PLANNING COMMISSION AGENDA

PLANNING COMMISSION STAFF REPORT

Public Hearing
Proposed Zone change
Applicant: Duane Johnson
Location: approximately 898 E. 7240 South
Acreage: approximately 13.86 acres

The Meadows Subdivision

Concept Plan

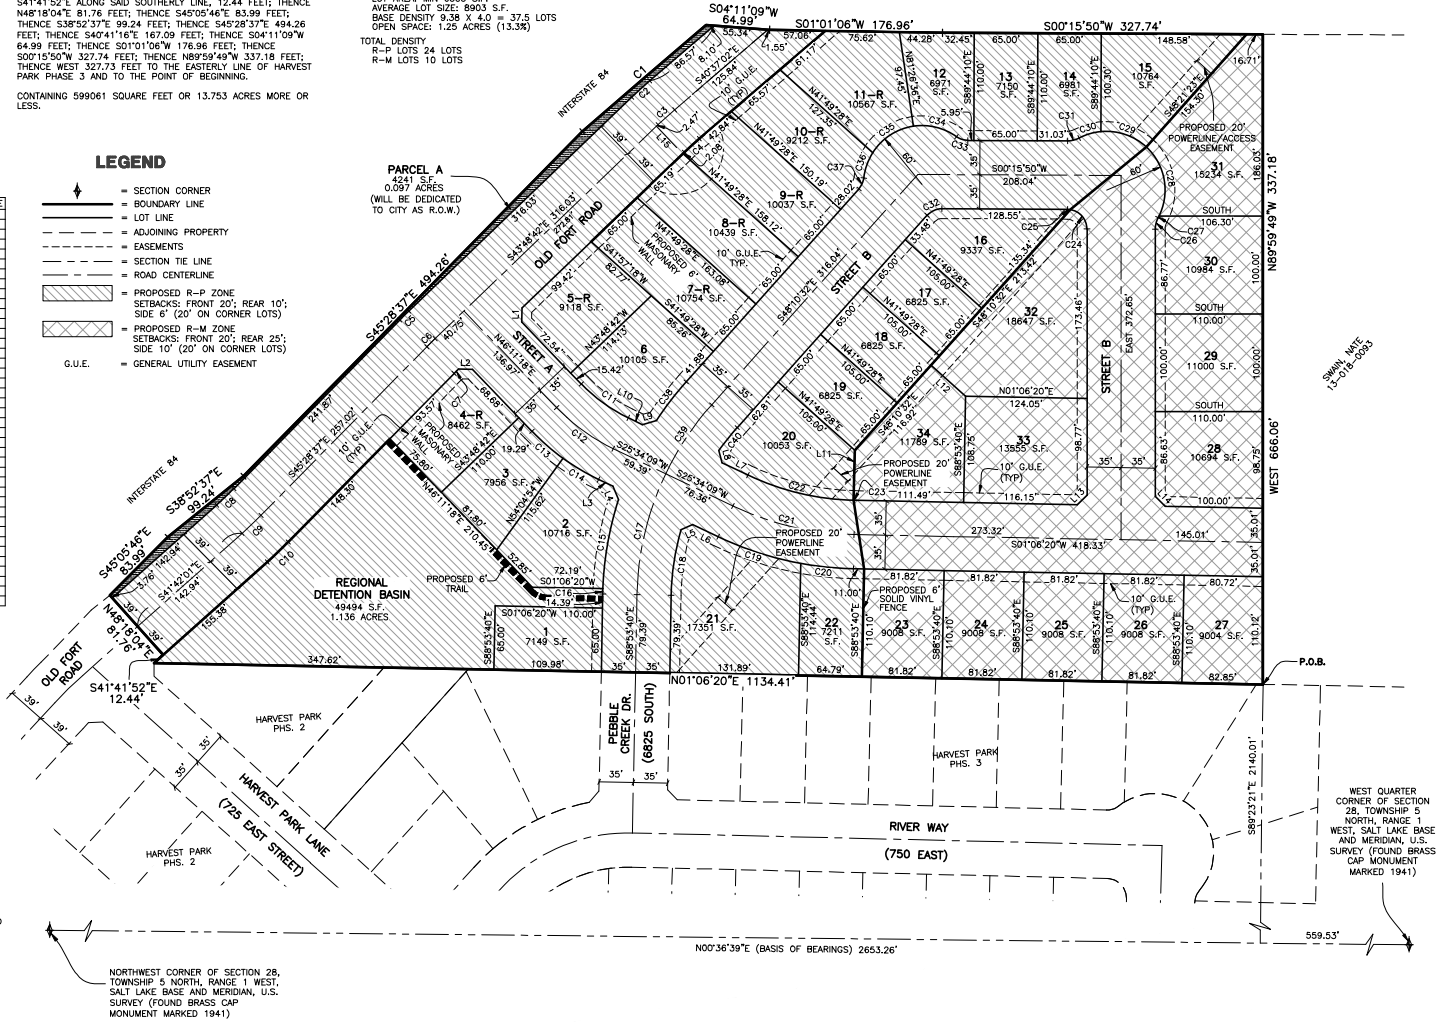
The General Plan Projected Land Use Map identifies approximately 10 acres at the northern portion of the property as R-P, the remaining property is designated for moderate density. The moderate zoning district portion is consistent with the General Plan land use designations for the property. The applicant requested 9.375 acres to be rezoned to the R-P zone. However, the R-P zone is not recommended unless an amenity is included in the project. As stated in the General Plan, this density requires additional amenity or benefit to the city to be approved.

The applicant submitted a Cost Share agreement, but there is little suggested as an improvement or benefit to the city to justify the increased density.

The traffic impacts of the potential development will be analyzed in detail during the subdivision process. However, the South Weber Vehicle Transportation Map shows that an east/west collector roadway is required to provide a road connection to the west and east of the project. Old Fort Road should be extended to accommodate additional traffic for potential development. A north/south collector road is also required by the general plan, connecting the Old Fort Road on the north to the future extension of Canyon Drive. These travel corridors as required by the General Plan will provide additional travel routes and distribute the traffic load on to multiple roadways and lessen the overall transportation impact while providing additional routes for emergency services.

The proposed zone change does not meet the goals and objectives of the General Plan as stated in the staff report. Staff recommends denial of the zone change for the 13.86 acres from A (Agricultural Zone) to R-M (Residential Moderate Density Zone on 4.379 acres) and R-P (Residential Patio Zone on 9.375 acres) on approximately 13.86 acres total.

SHEET TITLE: SITE PLAN

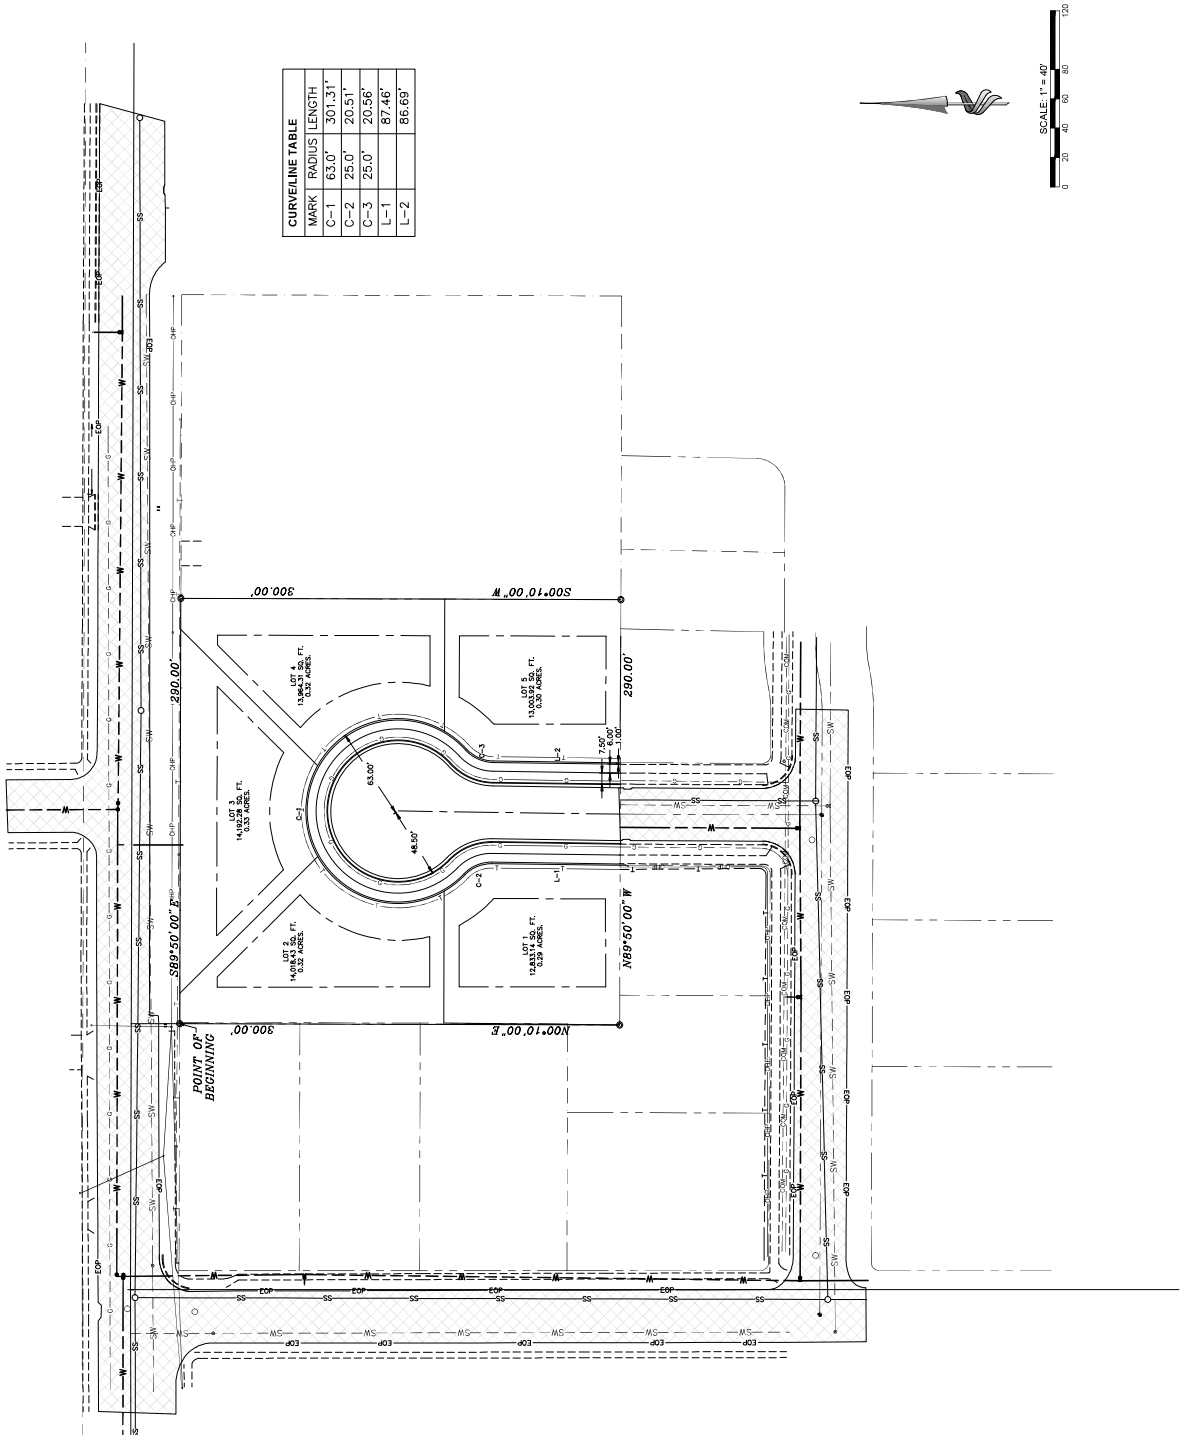
Staff has reviewed the proposed preliminary plat and recommends approval with the modifications to the plat as outlined in the staff report.

Engineering Comments: The City Engineer reviewed the Namazi Preliminary Plat and recommends preliminary plat approval based on the modifications required in his review memo.

COTTONWOOD ESTATES
PRELIMINARY PLAT - 'NOT TO BE RECORDED'

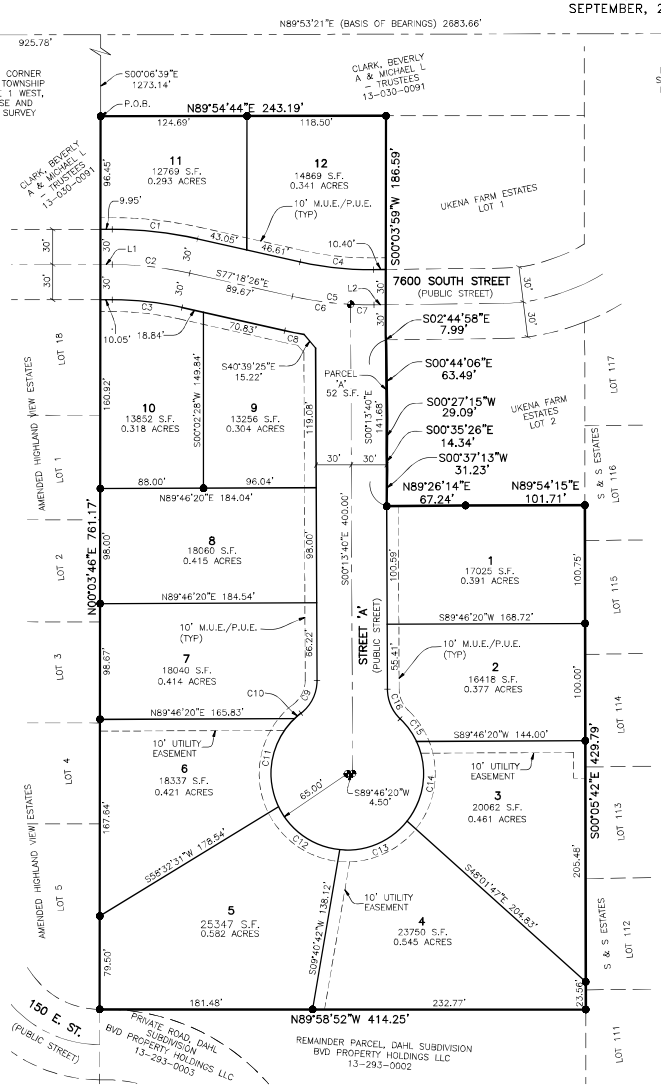
Staff has reviewed the proposed preliminary plat and recommends approval with the modifications to the plat as outlined in the staff report.

Engineering Comments: The City Engineer reviewed the Kap Legacy Preliminary Plat and recommends preliminary plat approval based on the modifications required in his review memo.
